Adaptation to scientific and technical progress under Directive 2002/95/EC

Final report

Freiburg, 20 February 2009

Öko-Institut e.V.

Figure 22 Consultants' proposal to change connector size preventing whisker short circuits

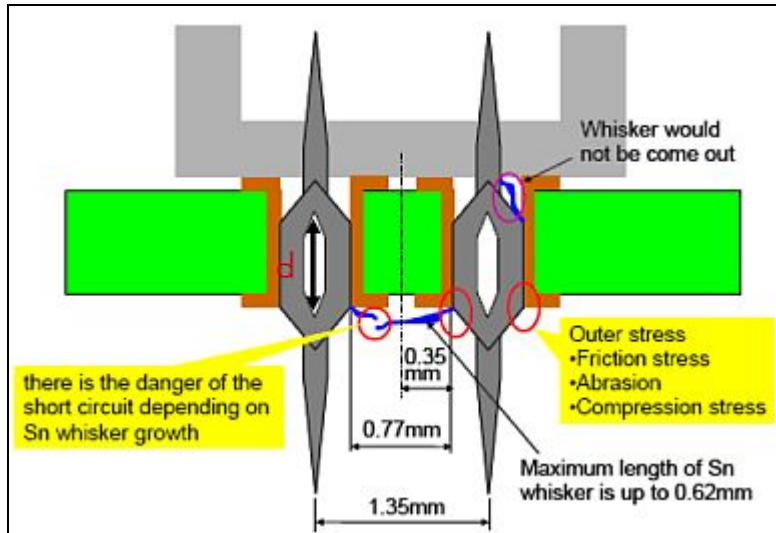
The consultants proposed the stakeholders to shorten the length d of the spline (Figure 22 below) so that the line where the spline ends touching the PTH is not at the bottom edge of the PTH as in the drawing, but still inside the PTH. The whisker would then have to grow

much longer and around the corner to be able to cause a short circuit. This change would at the same time reduce the insertion force, as the area where the PTH plating and the spline touch each other during insertion is much smaller.
